CORRESPONDENCE FROM THE APPLICANT

RE; 1187 Coast Village Road, Montecito.

Thank you for meeting me to review and discuss the preliminary plans for the tenant improvements and refurbishment of the building and landscape at 1187 Coast Village Road to determine what the impact will be on the existing Canary Island Pine Trees.

Existing 24" dbh Canary Island Pine with co-dominant stems

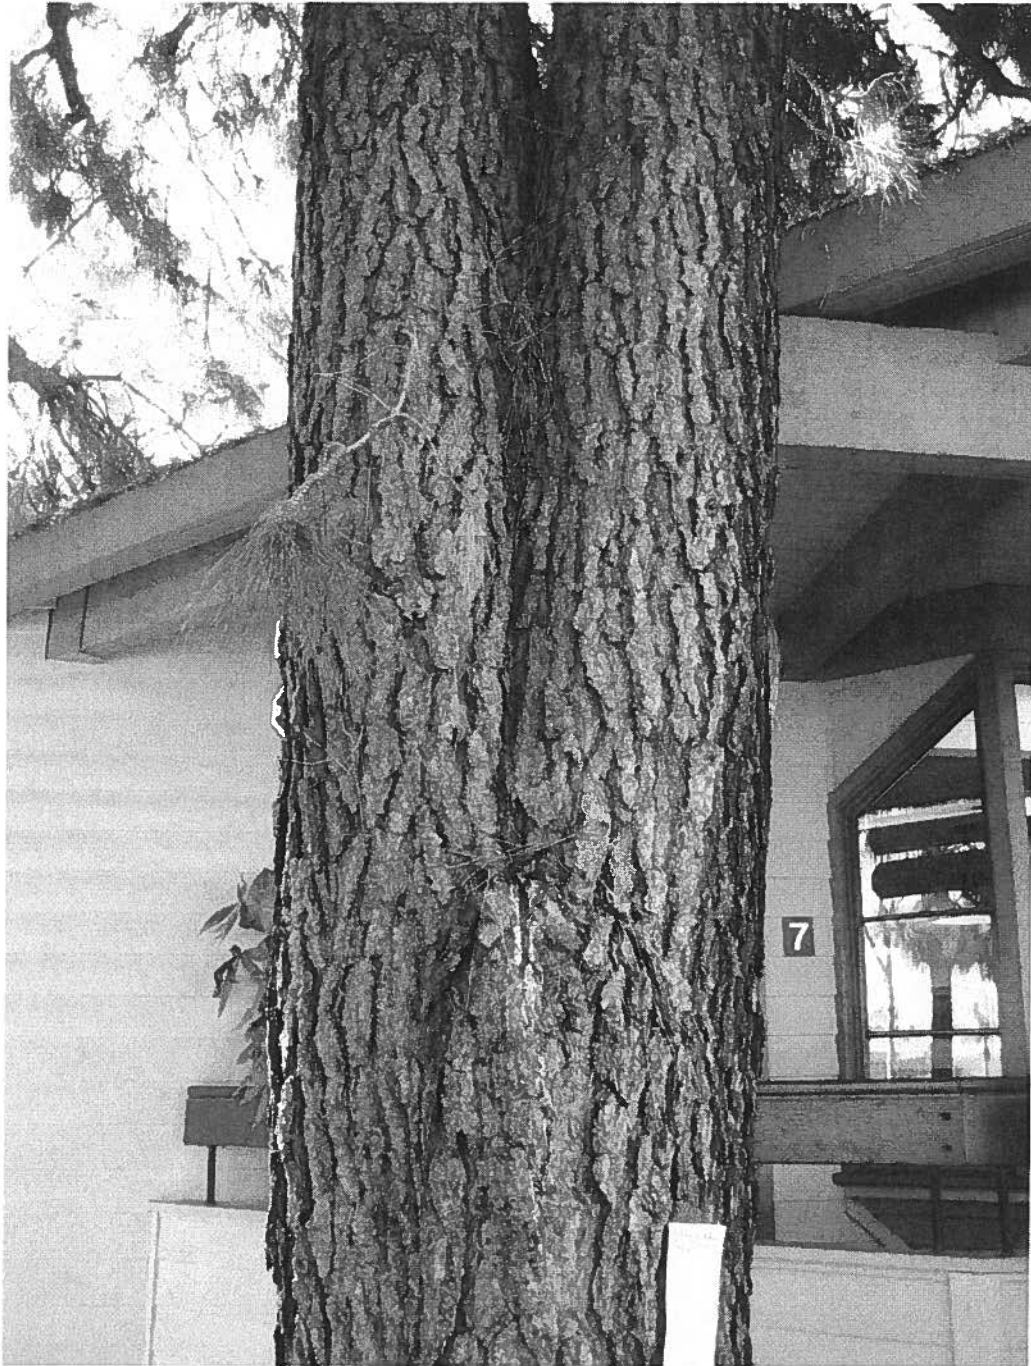
The other two 24" dbh Pines located on the northeast corner of the property adjacent to Coast Village Road are not good specimens due to structural imperfections. Superficially, as you glance at the trees that have formed one canopy they appear to be worthy skyline trees but upon closer examination I found this not to be the case. My primary concern is with the larger of the two trees closest to the building, it has two stems (commonly called codominant stems)

starting at about 6ft. Unfortunately, this is an extremely hazardous condition as the two stems have a tendency to split apart at any time and as the tree continues to grow and expand its trunk girth, there is a greater chance of failure. Given the surrounding target area of buildings, public streets, cars and pedestrians, I have to recommend its removal regardless of the any impact from the proposed project. Please see the attached site photographs, Attachment B.

Existing 16" dbh and 24" dbh Canary Island Pines located on the northeast corner of the subject property

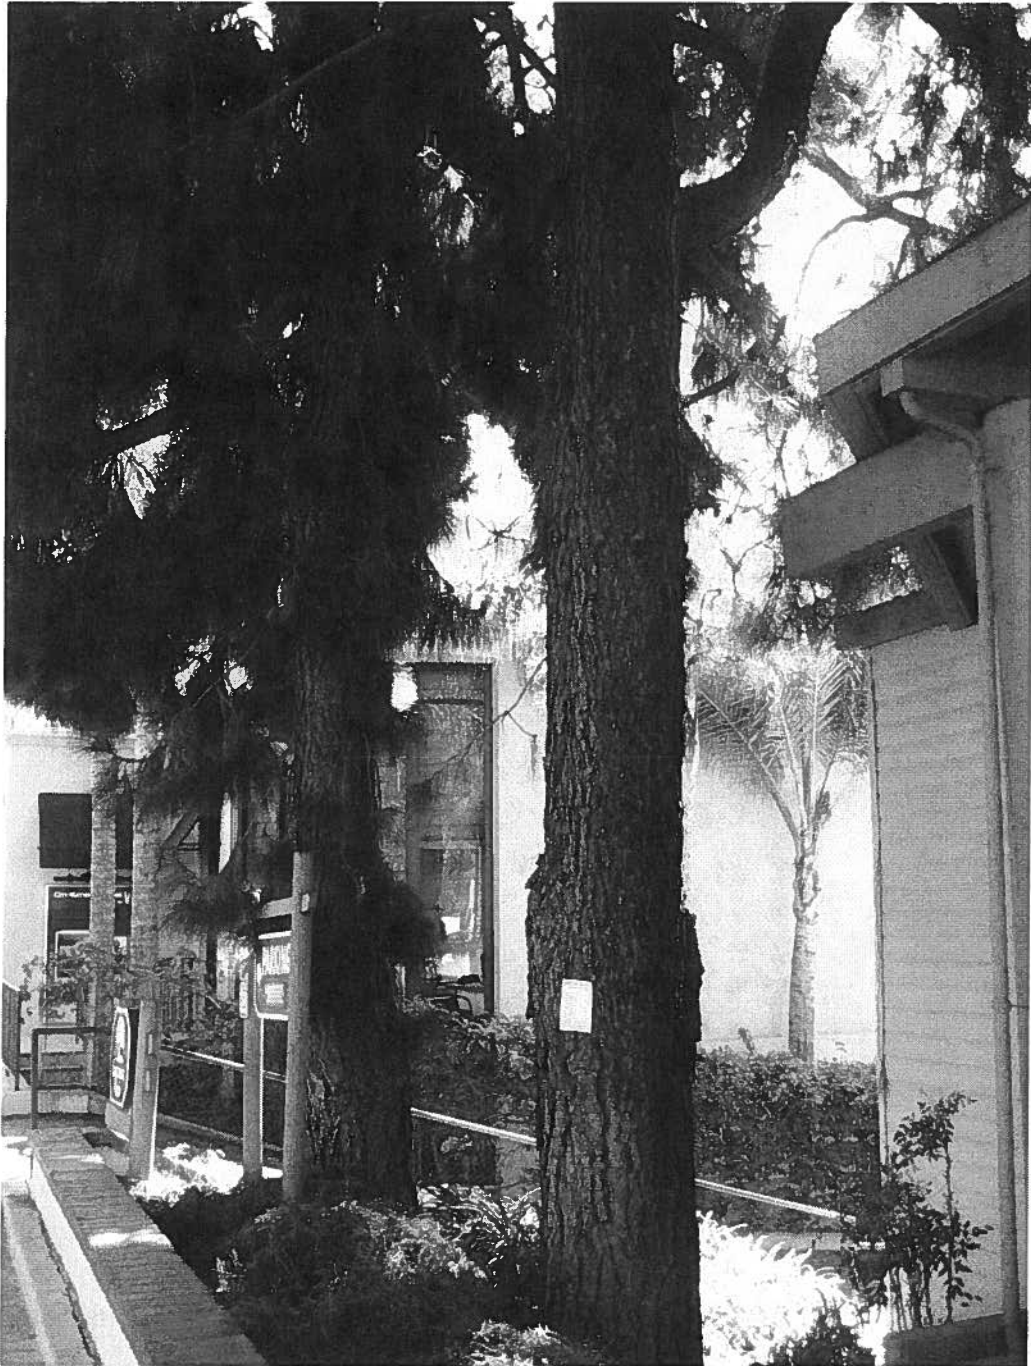
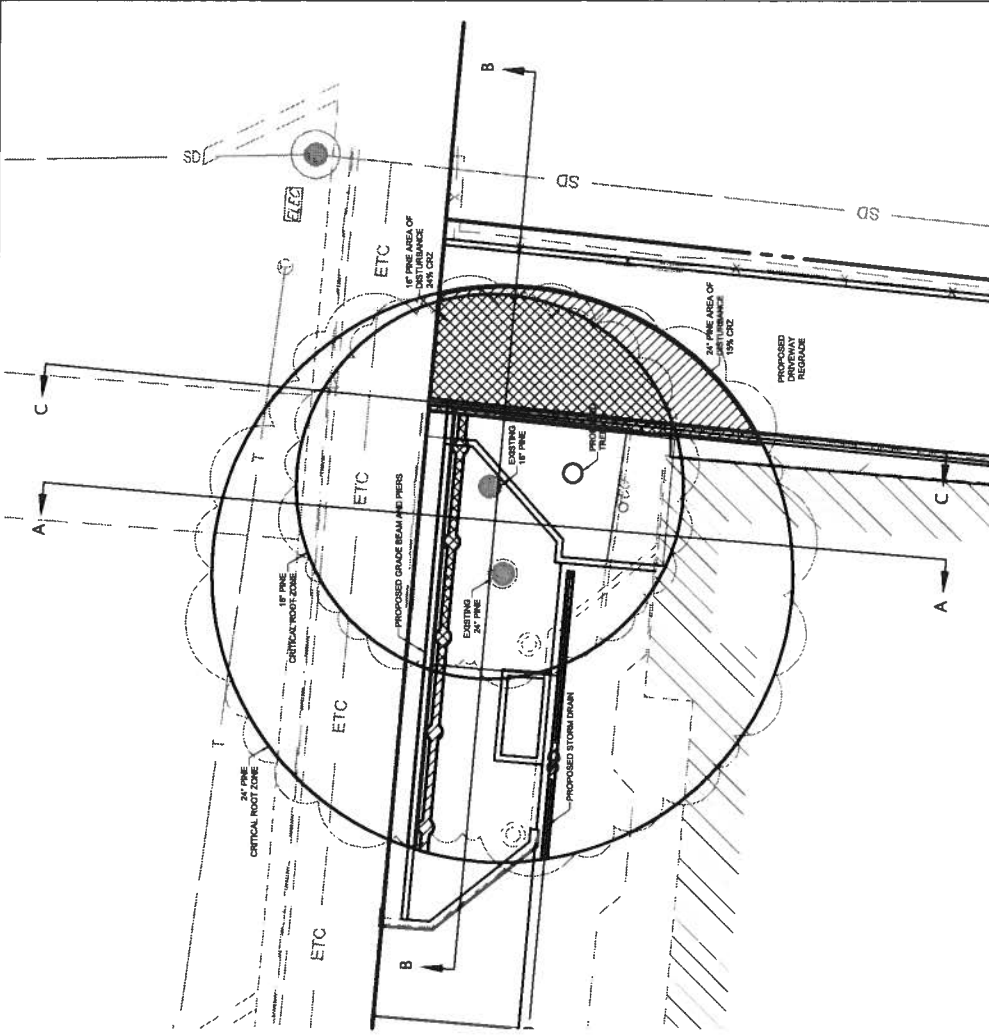
The remaining third 16" dbh Pine tree adjacent to the twin-stemmed Pine does have a lean to the east and all of its branches are on the east side of the tree due to being suppressed by its partner tree. Given I recommended the removal of the twin-stemmed tree, the remaining Pine will not only look out of place but will be susceptible to failure due to its weighted lean to the east and will be far more vulnerable to wind-throw. I feel it prudent to remove this tree also and replace with a new specimen tree in the same general location.

EXISTING TREE EXHIBIT
COAST VILLAGE PLAZA
SANTA BARBARA, CA
SEPTEMBER 10, 2015

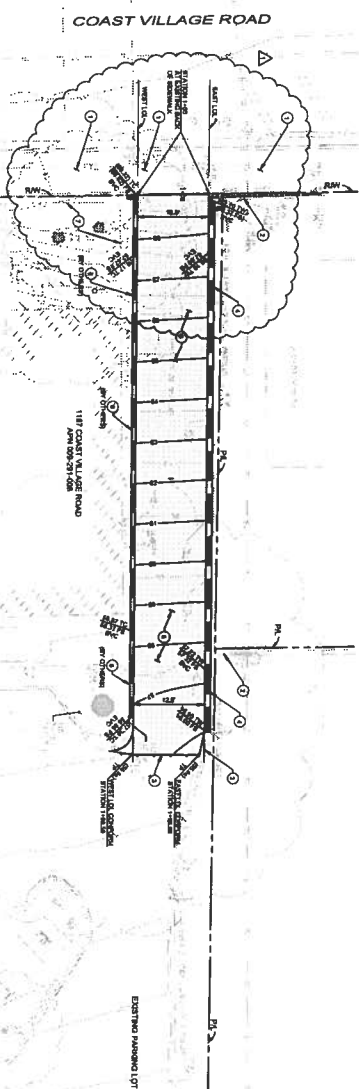
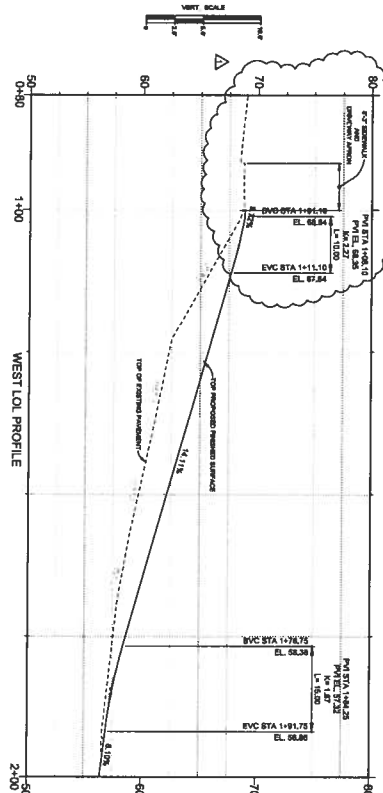
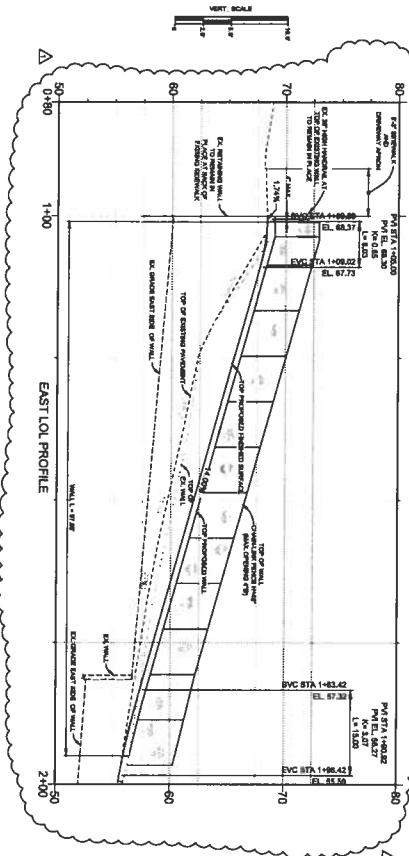
It is my understanding in reviewing the project plans (C1.0 Preliminary Driveway Plan and the Existing Tree Exhibit, Attachment A), that the proposed driveway improvements require grading, compaction, and installation of a new retaining wall. My primary concern is the three large Canary Island Pine trees (*Pinus Canariensis*) located on the north side of the building adjacent to Coast Village Road.

The proposed driveway improvements, storm drain and low retaining wall on the property frontage will result in encroachment of approximately 20% into the Critical Root Zone(s) of these Canary Island Pines. These trees typically have shallow root systems and as a result of the encroachment present additional hazard. Alternative construction methods are not recommended as they do not provide a feasible solution to address the safety hazard presented by the already poor specimens.
